SACHEM VILLAGE CONDOMINIUMS

MARLBOROUGH, CONNECTICUT

Eastern Connecticut Environmental Review Team Report

**Environmental Review Team
Report #493**

MAP REFERRED TO IN GEOLOGY SECTION

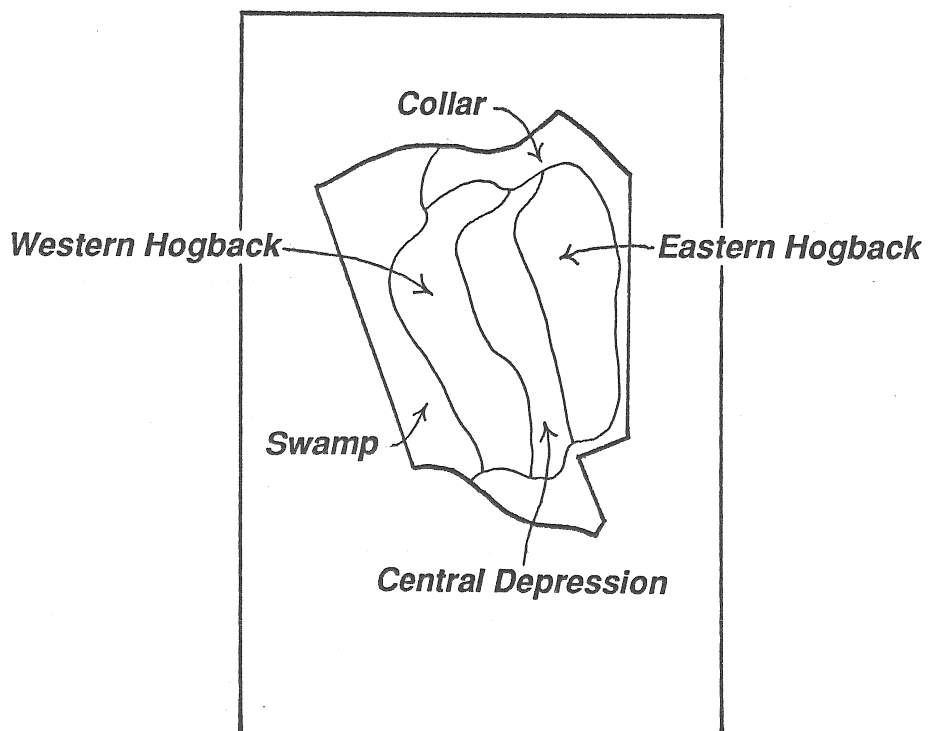
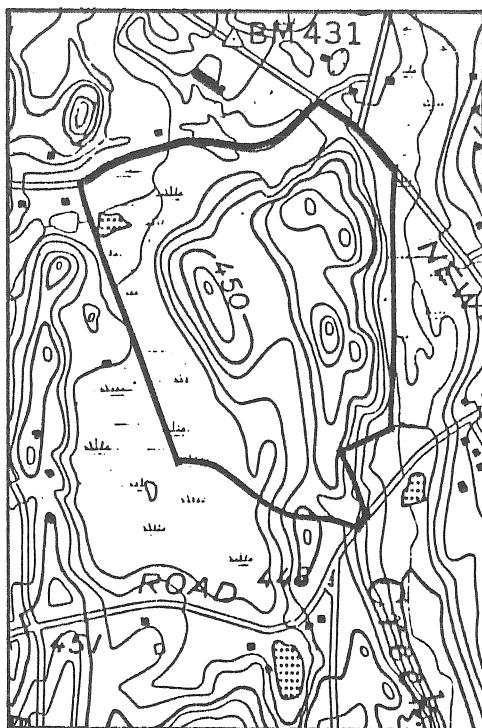
The Team Geologist saw nothing in the field that would conflict with the existing bedrock or surficial maps. In this sense, his reconnaissance of the property may be taken as supporting evidence that the mapping is correct. He did, however, make some site-specific observations that might be relevant. (Please refer to map)

1. The bedrock outcrops present near the ridgelines along the "*hogbacks*" appear to be resistant gneissic bodies within the schist, suggesting that the "*central depression*" is probably underlain by less resistant schist.

2. Dickinson Creek was examined at the road crossing. North and south of the road crossing it flowed as clear water in a set of braided pathways through a swampy floodplain. Near the bridge, the creek was artificially constricted into a channel about 20 feet wide. Here the bed of the stream was mantled with organic detritus and sand. At 11:00 am on the morning of May 14, flow was estimated to be 20 cubic feet per second, based on an estimated width of 20 feet, depth of 2 feet, and velocity of 0.5 feet per second.

3. Where exposed in excavation pits near buildings 2 and 3, the tills appeared to be very sandy, very heterogeneous and contain locally derived angular fragments of various sizes. Nothing resembling a compact clay-rich hardpan (basal) till was observed. The abundance of rounded pebbles in the meltwater deposits, and the generally pinkish color of the meltwater sands, stand in sharp contrast to the angular, schistose, locally derived character of the tills.

4. The edge of the swamp (large wetland mapped as swamp deposits) was examined with a bucket auger. At a depth of 1 foot, the irregular woody peats changed into a decomposed but firm felted grass/sedge peat. At a depth of 2 feet, this material became interbedded with silt layers near its base above compact cleanly washed sand. This stratigraphy suggests that the basin began as a postglacial pond which was later occupied by a marsh. Historic activities not related to the Sachem Condominium project then caused the wetland to change into its present shrub/scrub status.

5. The "*central depression*" is much more uniform in its topography than in its content of unconsolidated material. Near the northern side, in the vicinity of building #1, the surface meltwater deposits range in thickness from 1 to over 20 feet depth, and in material from cobble/pebble gravel to loamy sand. In the center of the depression, coarse mixtures of rock and silt over silts and cleanly washed medium sands. The southern sector of the "*central depression*" is dominated by a broad gently sloping surface with a closed depression. Here, the surface materials are sandy, but the vegetation and topography suggests seasonally wet conditions. This suggests that impermeable lacustrine materials occur at depth.

6. The closed depression on the property adjacent to Hodge Road contains a thin fill of mineral-rich soil with historic artifacts, and bounding slopes that appear to have been recently excavated. This area, specifically described by John Ianni (applicant's soil scientist) as not containing a wetland, seems to be an artificially created depression associated with road construction and drainage improvements.

FILTER FABRIC SILT BARRIER AT C.B.

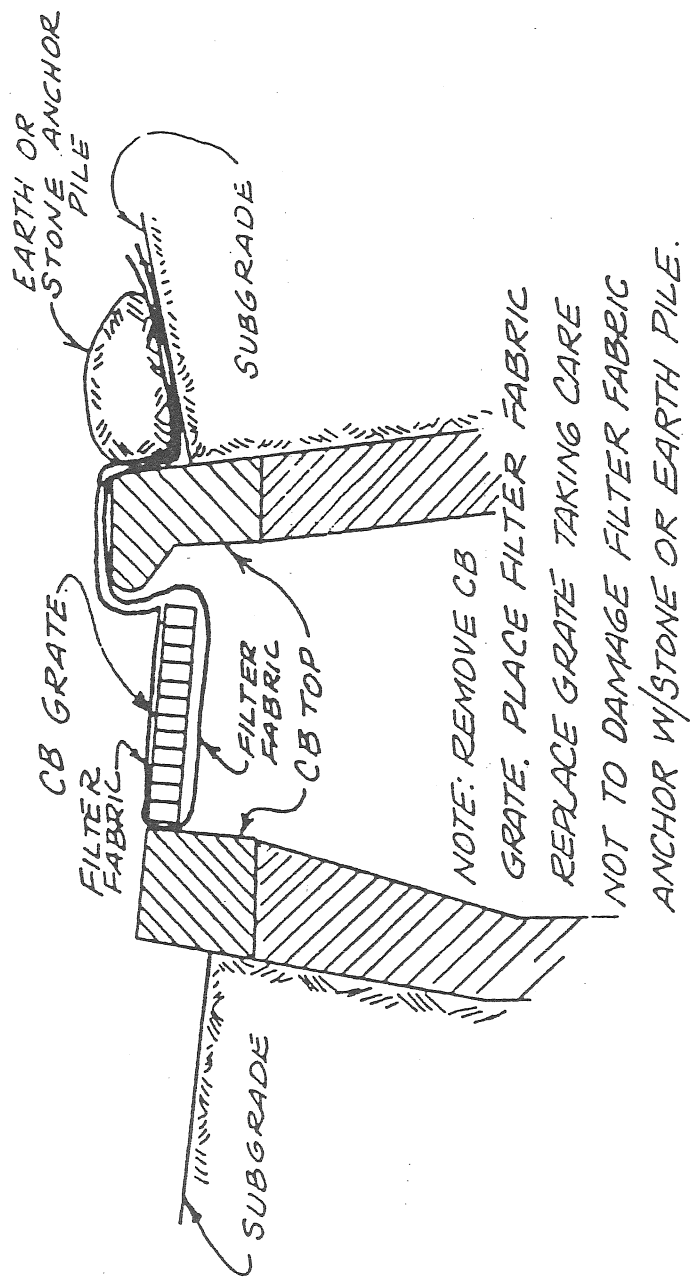
2. All the catch basins on the site should be protected by some type of filter fabric envelope. Please see enclosed example.
3. Locate directly on the plan items such as, but not limited to:
 - a) Construction entrance locations and details for each phase and
 - b) Location(s) of stockpiled topsoil and topsoil erosion control protection measures.
4. Temporary E&S control measures should be specified when time of year or weather prohibit establishment of permanent vegetative cover. The recommended dates for establishing temporary vegetation, specifically annual rye grass, include:
